DEVIATION REVIEW AND DECISION FORM

Subdivision or Project Name: The Beach at Woodmoor

Section of ECM from which Deviation Is Sought: 2.3.2 Table 2.7

Proposed Nature and Extent of Deviation: Allow a reduced centerline radius (a 65-foot centerline radius) for the Urban Local Low Volume subdivision street south of Lake Woodmoor Drive – standard is 100 feet.

Figure 10

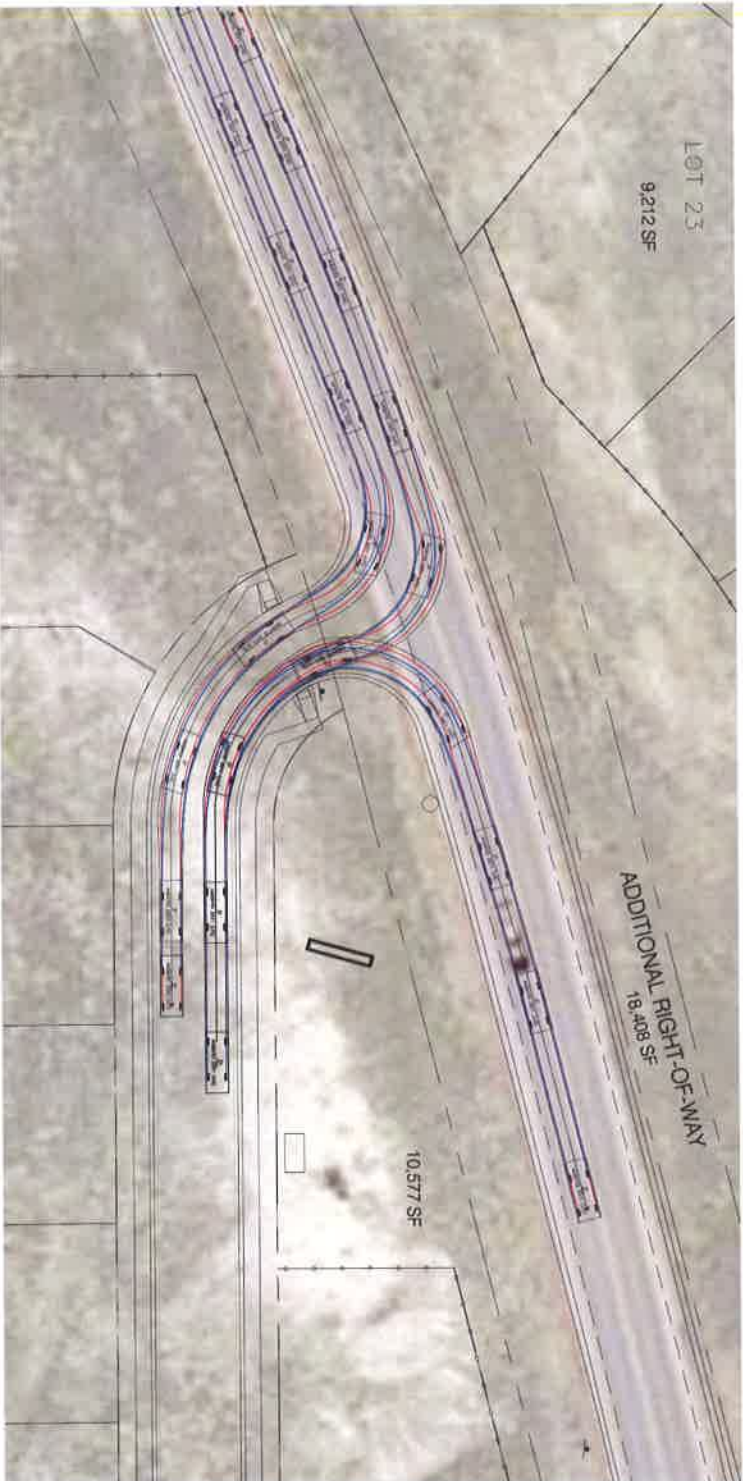
The reduction of the centerline radius from 100 feet to 65 feet will not affect safety or operations. This will be a low volume street with a relatively short length. Please refer to the attached AutoTurn vehicle turning analysis exhibits.

CONDITION: APPROVAL CONDITIONED ON MEETING ALL OTHER COUNTY LOCAL LOW VOLUME URBAN CLASSIFICATION CRITERIA FOR PUBLIC ROADWAYS AND ACCOMODATION OF SNOW PLOW TURNING MOVEMENTS. DEVIATION WILL BE VOID IF FINAL PLAN IS NOT APPROVED BY BOCC (SF-17-015).

Figure 11
Snow Plow
Auto Turn Movements
 Woodmoor Beach (LSC #164800)

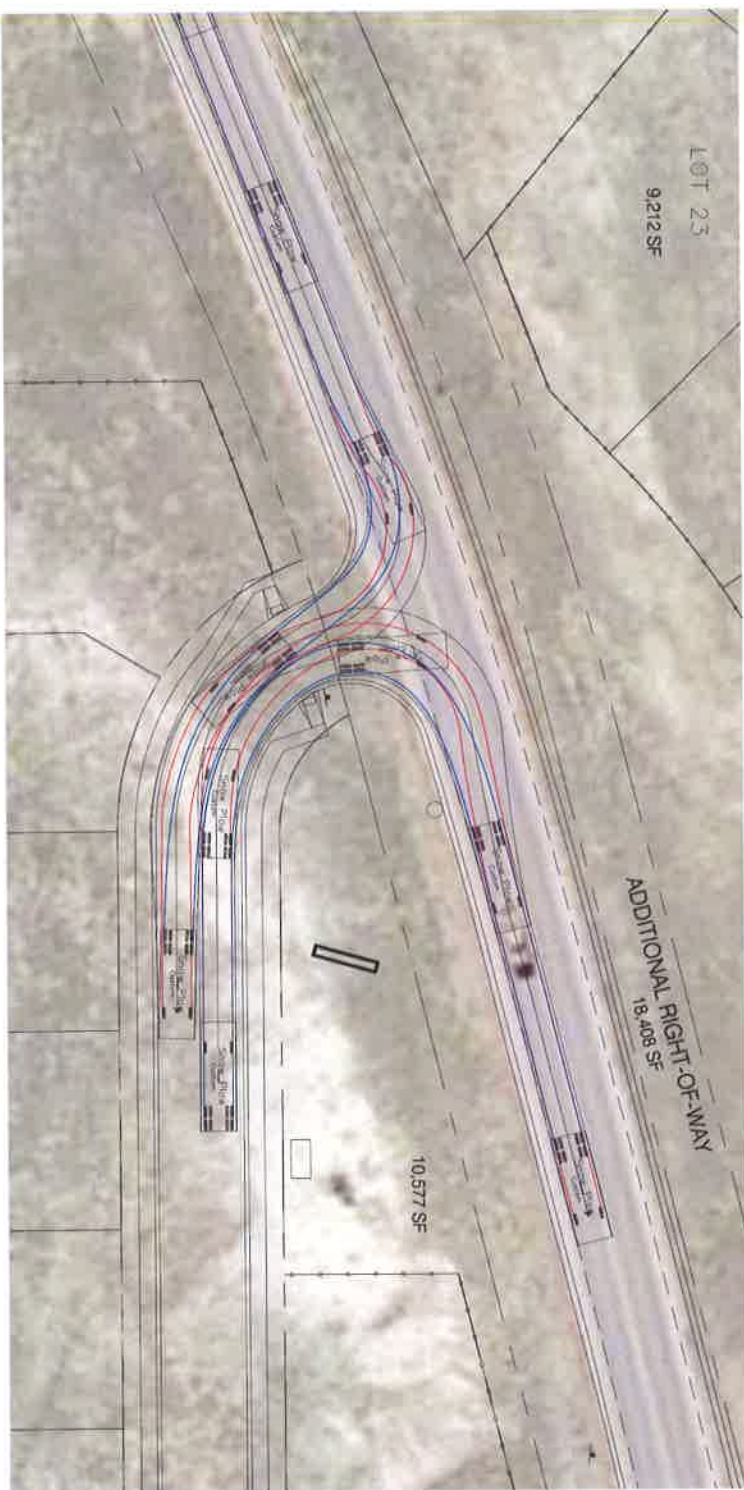
The deviation would not adversely affect maintenance as snow plows would be able to navigate the proposed curve.
